Tillbridge Solar Project
EN010142

Volume 6
Environmental Statement Addendum
Document Reference: EN010142/APP/6.6

September 2024
Revision Number: 00

FIGURE NUMBER
Figure 5

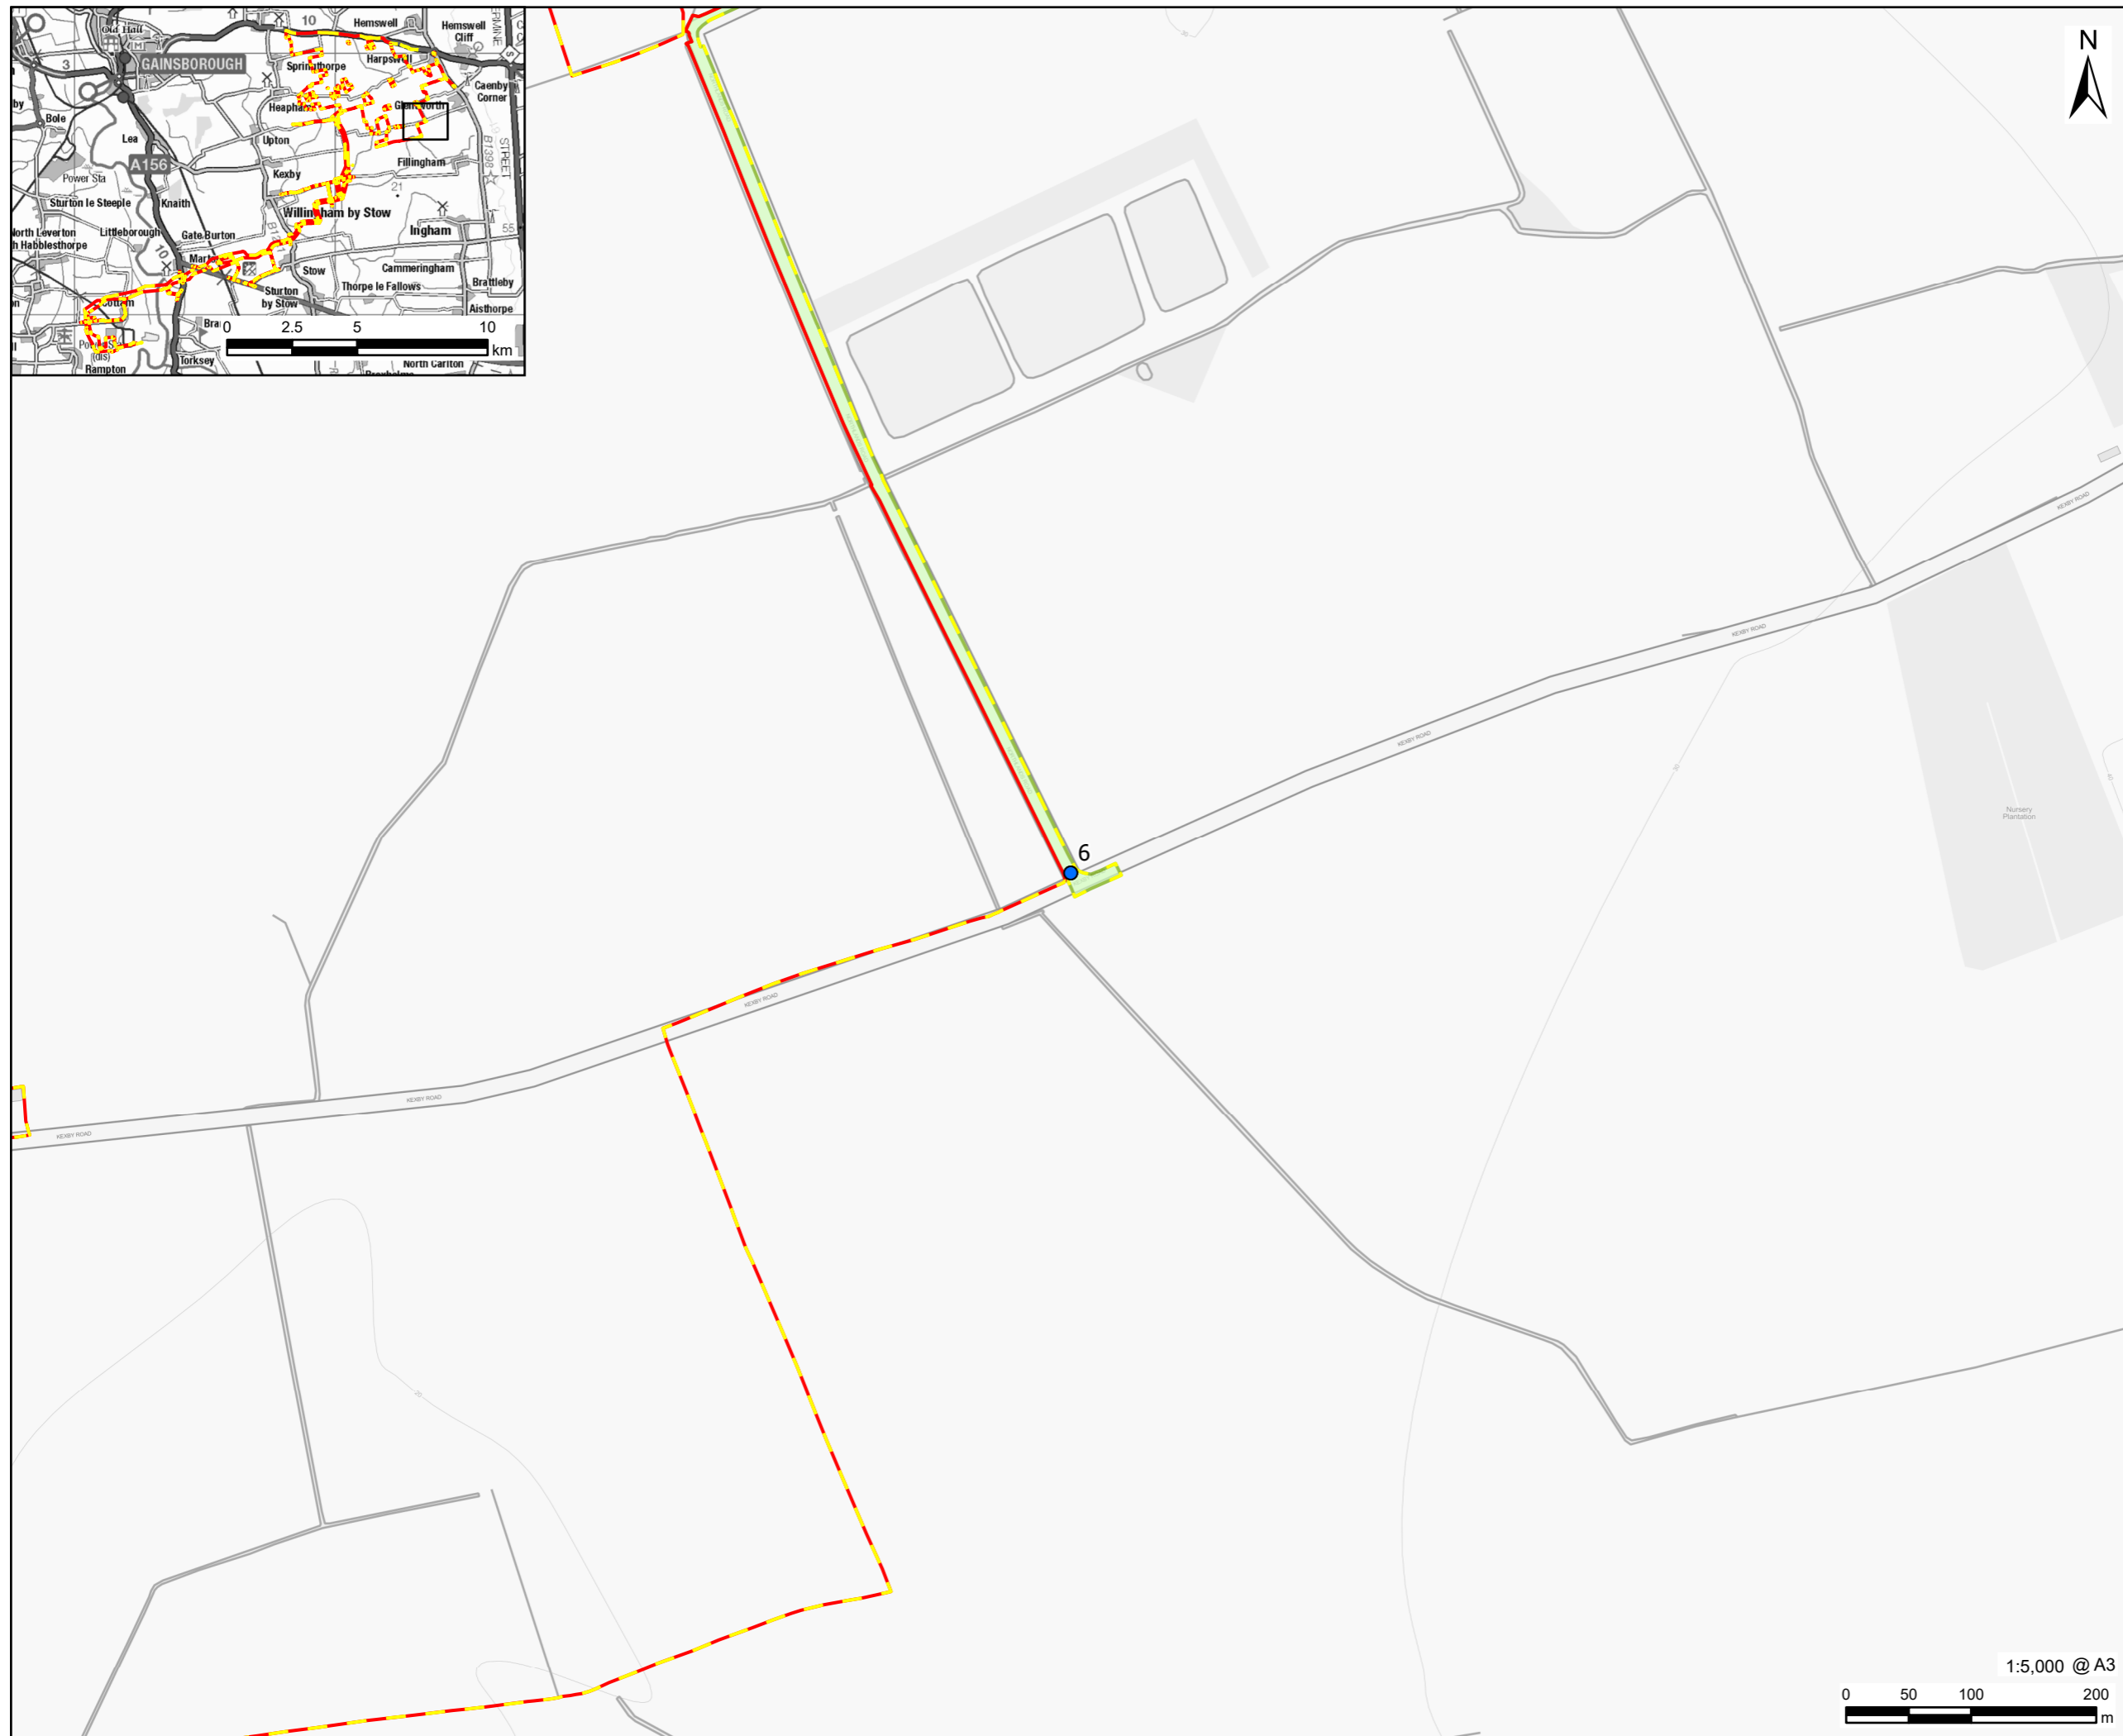
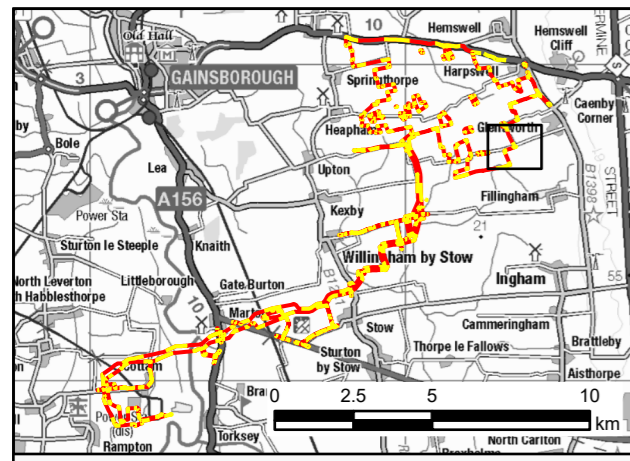
- 2.1.11 An additional temporary access will be provided off School Lane to the north of the proposed Access 1/14 for Substation B, referred to as Access 1/35, as shown on the **Streets, Rights of Way and Access Plans [EN010142/APP/2.4(Rev01)]**, to facilitate access to a temporary construction compound. A second permanent access will also be located north of Access 1/14, referred to as Access 1/34, to provide a second access to the proposed substation as shown on the **Streets, Rights of Way and Access Plans [EN010142/APP/2.4(Rev01)]**. In addition, the location of Access 1/14 has been adjusted to accommodate the revised layout.

- 2.1.12 The refined layout (see **Figure 5: Change 5 & 10**) will mean that the substation is served by a one-way access system ensuring that construction and operational vehicles can enter and exit the substation safely, in a forward gear, from and onto School Lane. This change will not amend the Order limits and has arisen through further technical considerations and the need to segregate the movement of vehicles associated with the construction of the Cable Route Corridor and the construction of Substation B.

- 2.1.22 Following ongoing discussions and engagement with Affected Parties, it is proposed that the Order limits are reduced to exclude land that relates to a private driveway serving a dwelling (see **Figure 5: Change 5 & 10**). The private driveway is not required for access to construct the Scheme. As a result, land from Plot 1-10 as shown on the **Land and Crown Land Plans [EN010142/APP/2.2(Rov01)]** has been reduced and modified to remove the private driveway from the Scheme.
- 2.1.23 This change will not result in a change to the Scheme layout. No new land interests would be engaged through this change. No additional land outside the current Order limits is required.

FIGURE NUMBER
Figure 6

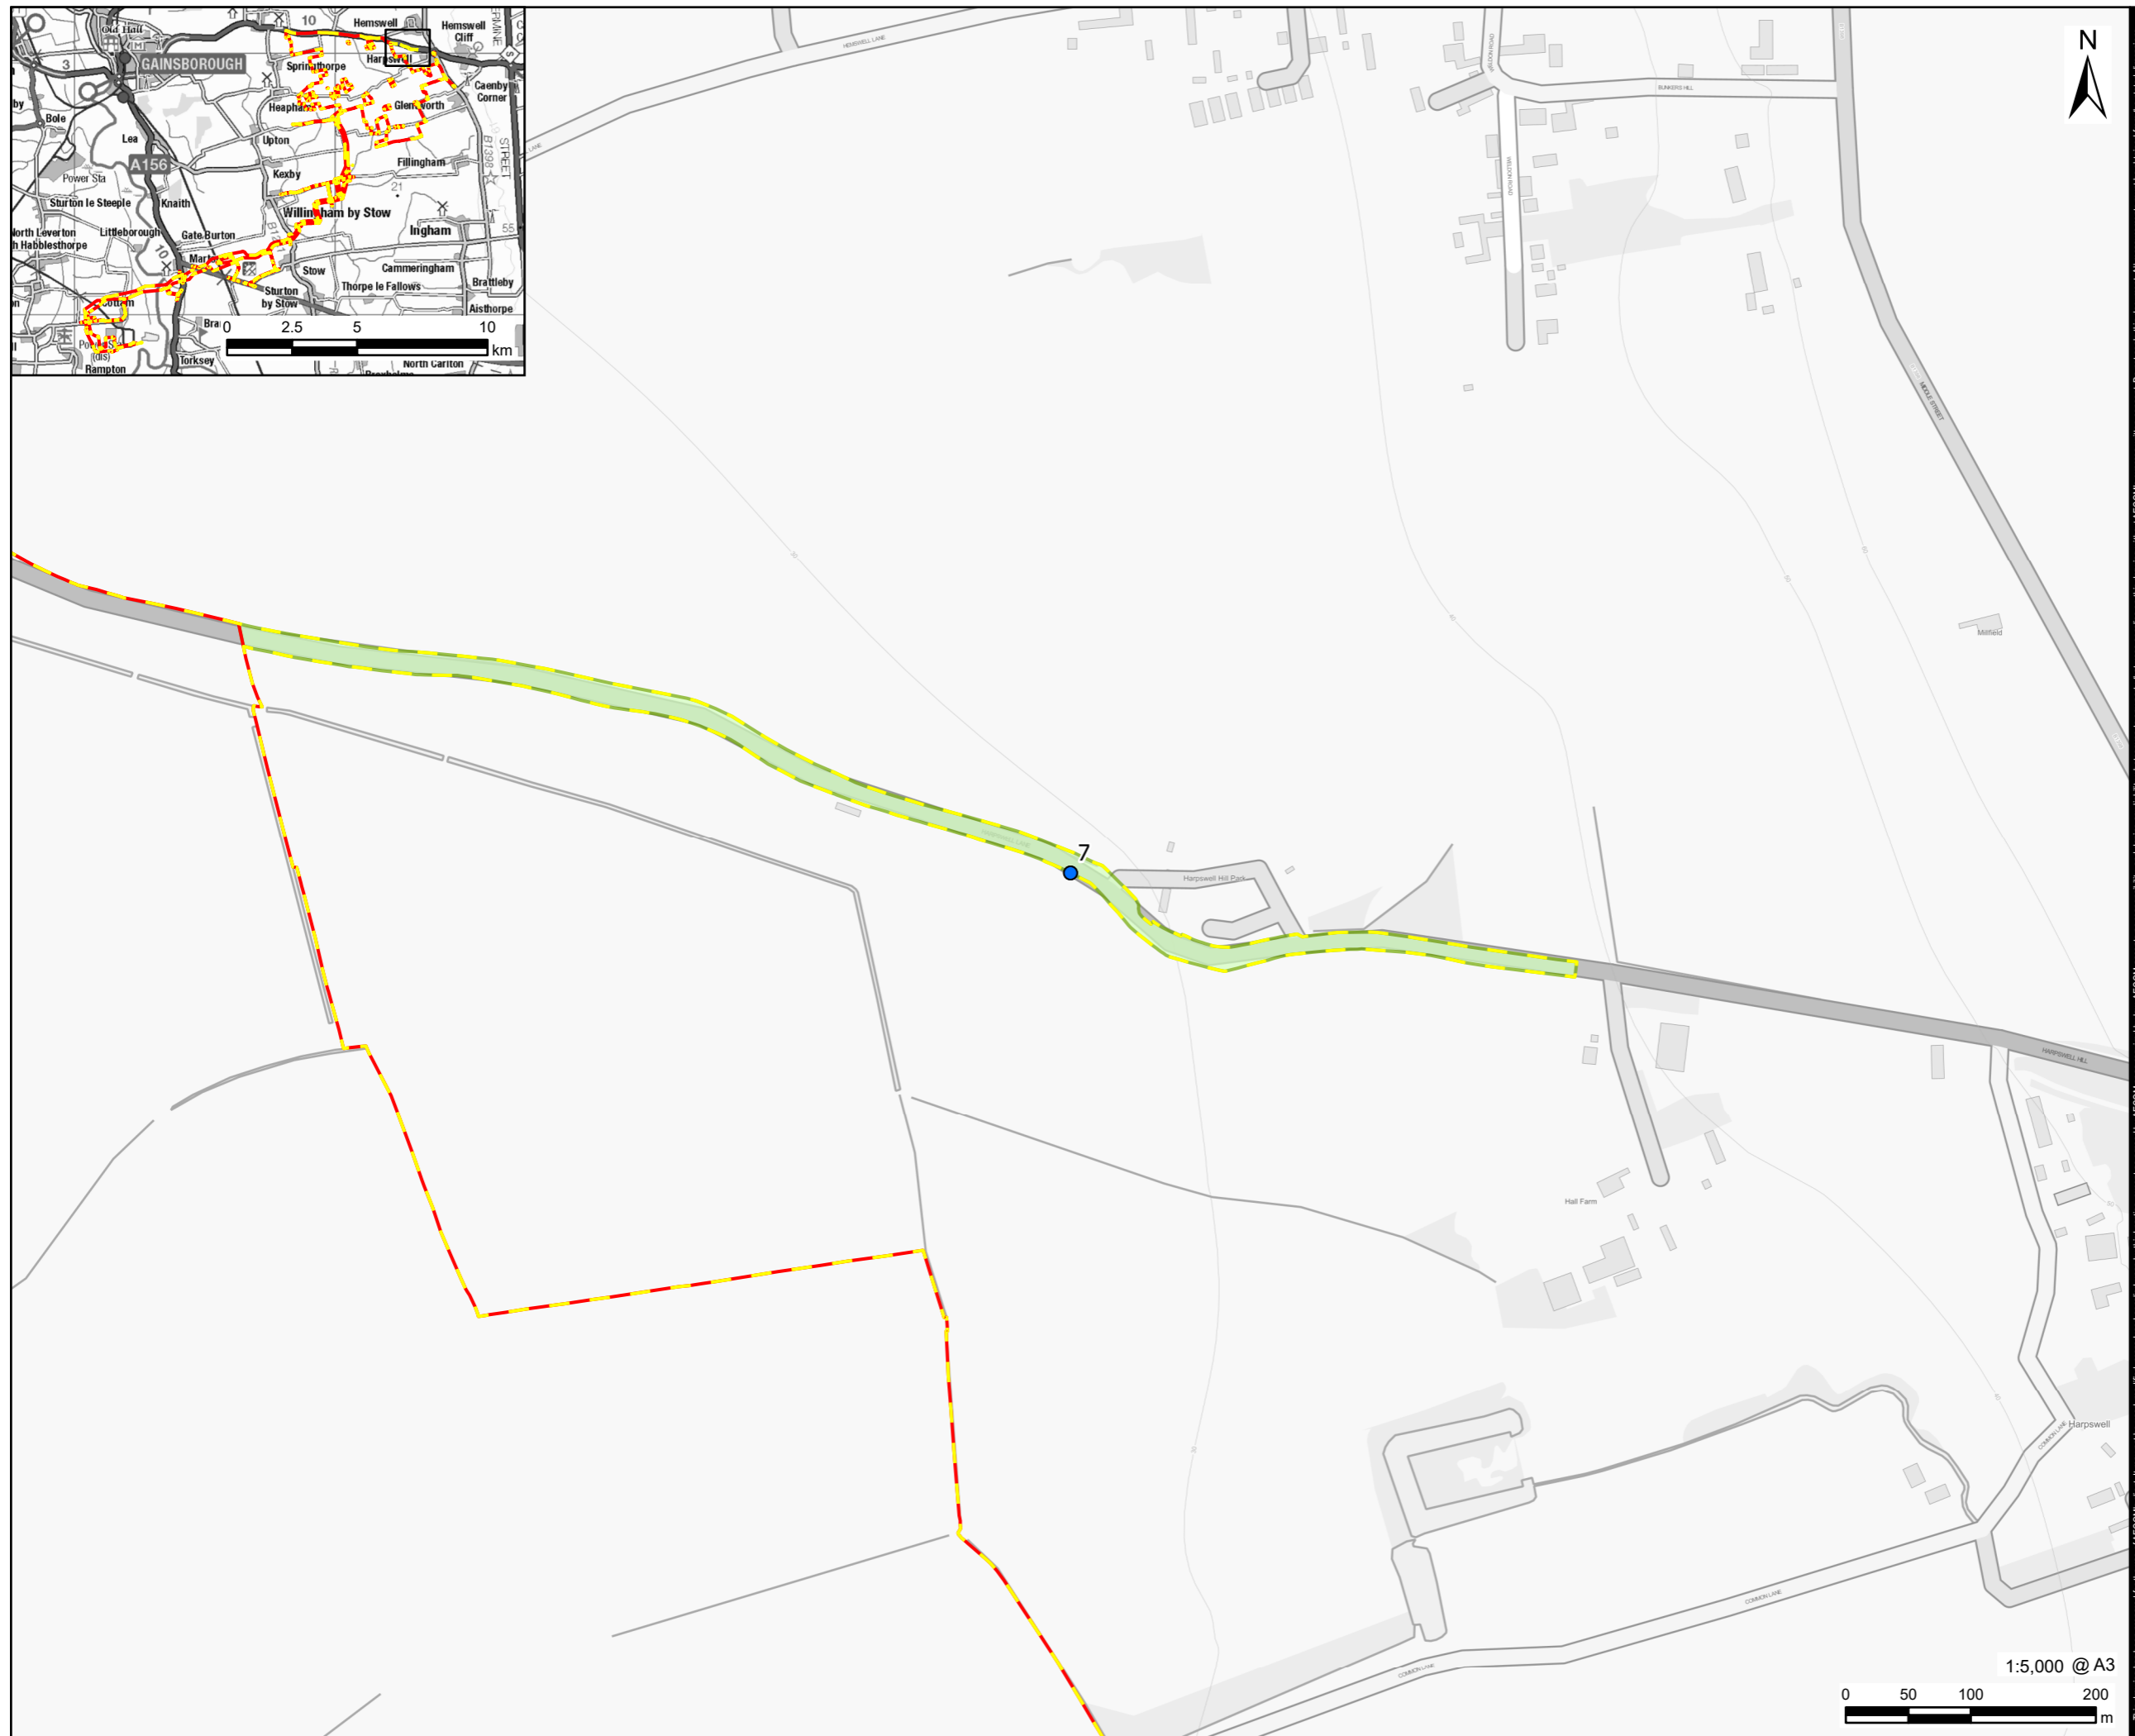
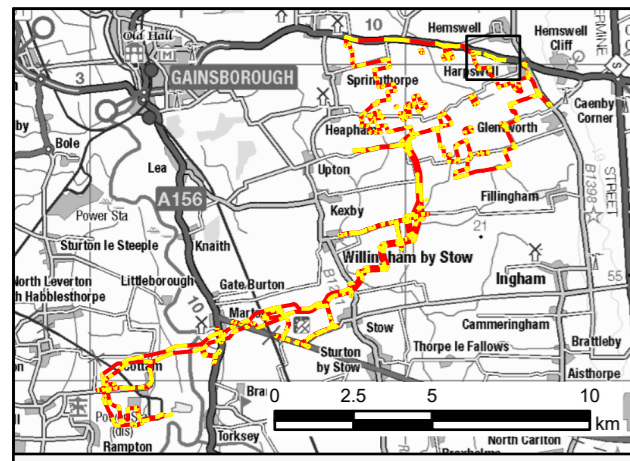
- 2.1.14 This change (see **Figure 6: Change 6**) will result in the removal of highway extents along Northlands Road and Kexby Road, which the Applicant has determined are no longer required for access. The area of land included within the Order limits at this location would reduce as a result of the change.
- 2.1.15 This change will not result in a change to the layout of the Scheme or engage any new land interests.
